CHANGE REQUEST

⌘ **24.008 CR 391** ⌘ rev **1** ⌘ Current version: **4.1.1** ⌘

Title:	⌘ Equivalent handling of PLMNs with different PLMN codes		
Source:	⌘ Motorola, Telia, Vodafone		
Work item code:	⌘ GSM-UMTS INTERWORKING	Date:	⌘ 5 March 2001
Category:	⌘ A	Release:	⌘ REL-4
<p>Use <u>one</u> of the following categories:</p> <p>F (essential correction) A (corresponds to a correction in an earlier release) B (Addition of feature), C (Functional modification of feature) D (Editorial modification)</p> <p>Detailed explanations of the above categories can be found in 3GPP TR 21.900.</p>		<p>Use <u>one</u> of the following releases:</p> <p>2 (GSM Phase 2) R96 (Release 1996) R97 (Release 1997) R98 (Release 1998) R99 (Release 1999) REL-4 (Release 4) REL-5 (Release 5)</p>

Figure 10.5.z/3GPP TS 24.008 *PLMN List* information element

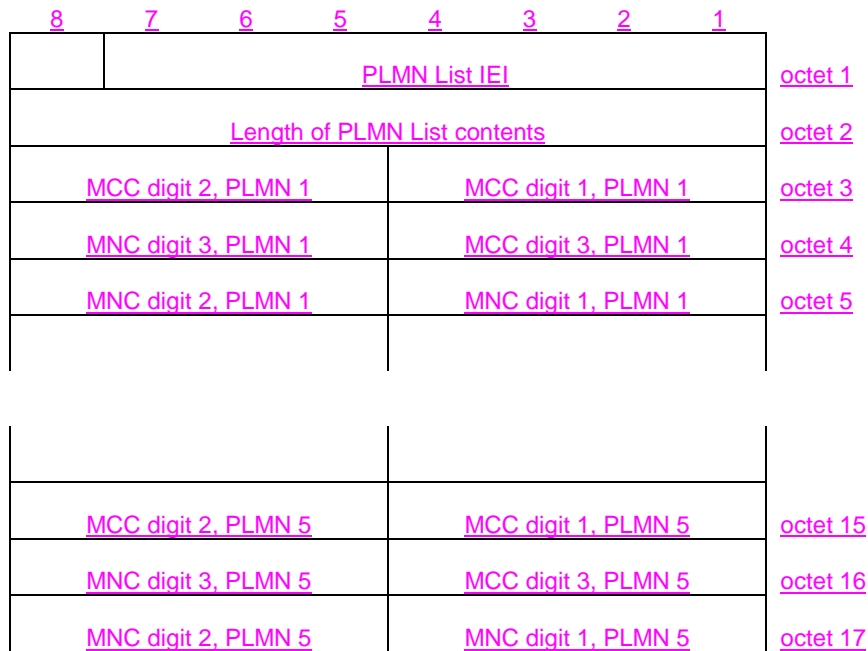
The purpose of the *PLMN List* information element is to provide a list of PLMN codes to the mobile station.

The *PLMN List* information element is coded as shown in figure 10.5.z/3GPP TS 24.008 and table 10.5.w/3GPP TS 24.008.

The *PLMN List* is a type 4 information element with a minimum length of 5 octets and a maximum length of 17 octets.
